Reviewed for Code Compliance
Inspections Division
Approved with Conditions

Framing Plan for 2nd

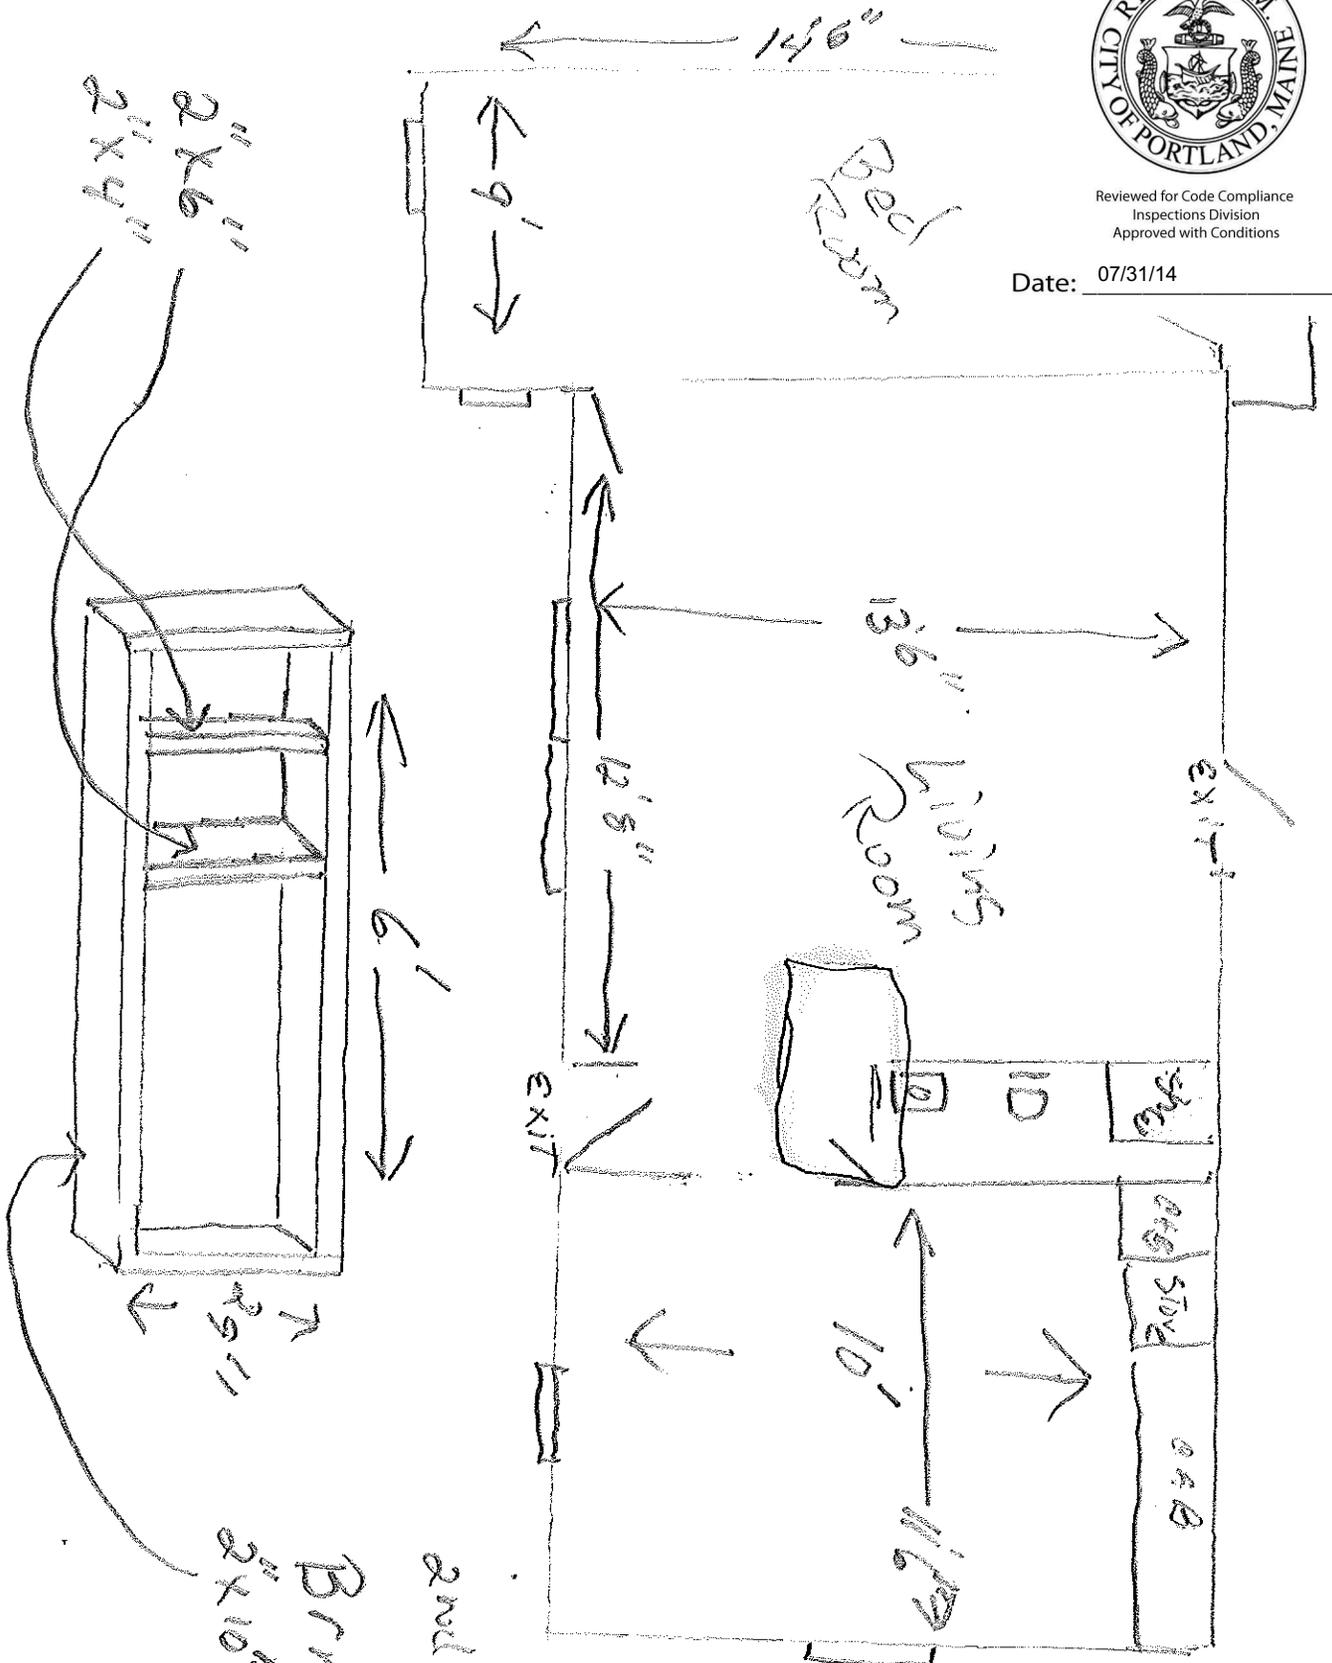
2nd Floor
BRACE FLOOR
2x10"
